Subject: Fuel Leak Case [REDACTED] Exxon #7-4121, 10605 Foothill Blvd.,  
Oakland, CA 94605

Alameda County Environmental Health staff has reviewed the case file for the subject site including the October 27, 2006 Additional Risk Assessment and Well Installation Work Plan Former Exxon Retail Site 7-4121 10605 Foothill Boulevard Oakland, California prepared by ETIC Engineering. This report proposes additional soil vapor sampling and monitoring well installation subsequent to the findings of your April and May 2006 investigation. We generally concur with the work plan, however, we have the following technical comments and request you submit the technical report requested below.

**SITE PLAN**  
 FORMER EXXON RS 7-4121  
 10605 FOOTHILL BOULEVARD  
 OAKLAND, CALIFORNIA

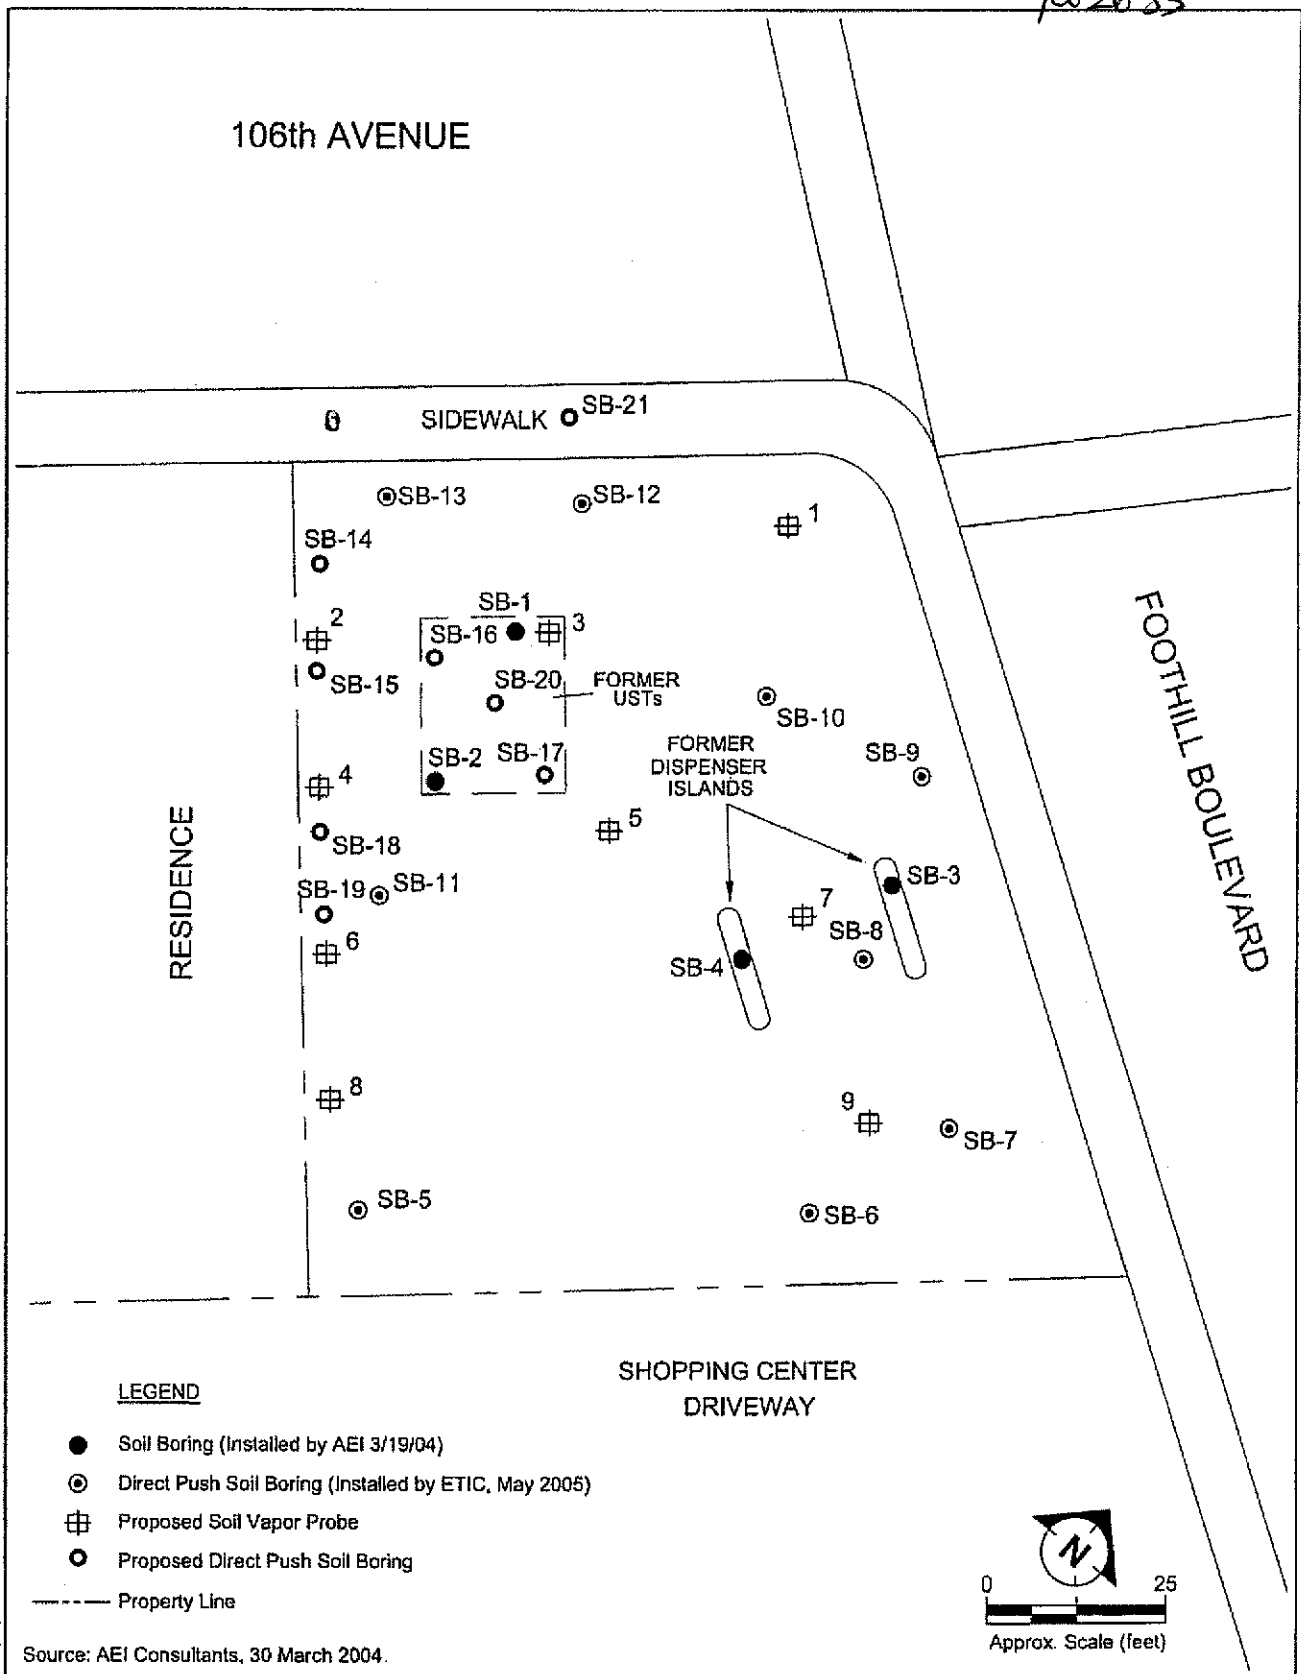
I have attached a copy of the revised map with boring locations based on our telephone and e-mail conversations. We are currently working to get an encroachment permit from the City of Oakland for the boring in the sidewalk. We anticipate drilling as soon as January 2006. Please let me know if you have any other comments regarding the boring locations.

\*The boring across 106th Avenue (see approximate proposed location SB-21 on attached map) will be for TPHg definition, not MTBE definition. Additional borings for MTBE definition will not be drilled.

The revised locations for SB-16 and SB-17 and the locations of the additional requested borings SB-19, SB-20, and SB-21 are shown on the attached map.

\* email response on 10/10/05, requesting borings on the south side of 106th not north. (2), to delineate plume.

Sherris:  
Apparently there was a misunderstanding during our prior conversation. When I suggested that the release from the former USTs should be further defined towards 106th Ave, I meant the apparent plume from the former USTs extending towards SB-12 and SB-13 should be defined in this direction. I assumed this would be done by advancing borings within the sidewalk on the southern side of 106th Ave., not the north side as shown in your attached figure. If SB-21 were impacted in soil and groundwater, it would be a stretch to say that SB-12 and SB-13 contamination came from across 106th Ave. I think SB-21 might be a good indication of whether a release had occurred from former USTs on the current commercial property but additional data would be necessary to link contamination in this boring and contamination on the referenced site. Such data might include sampling from the median of 106th Ave. Re: MTBE analysis, I agree that we do not need to delineate MTBE in groundwater, I only suggest that MTBE be run on samples "up-gradient" of the site, so as to determine a source for the low levels reported in SB-12 and SB-13.
